TRI-LAKES MONUMENT FIRE PROTECTION DISTRICT 15455 Gleneagle Drive, Suite 230

December 1, 2017

El Paso County Development Review Attention: Nina Ruiz File Number: ADR-17-019

Applicant: Arvidson Rezone

FIGURE D103.1 MINIMUM DEAD-END FIRE APPARATUS ACCESS ROAD TURNAROUND.

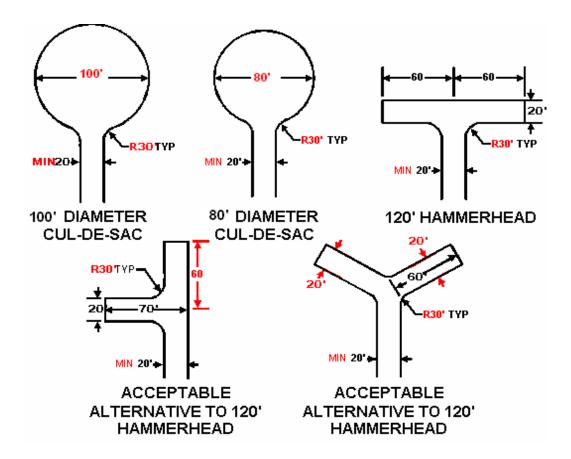
Figure D103.1. Dead-End Fire Apparatus Access Road Turnaround. Delete Figure D103.1 and replace with the following:
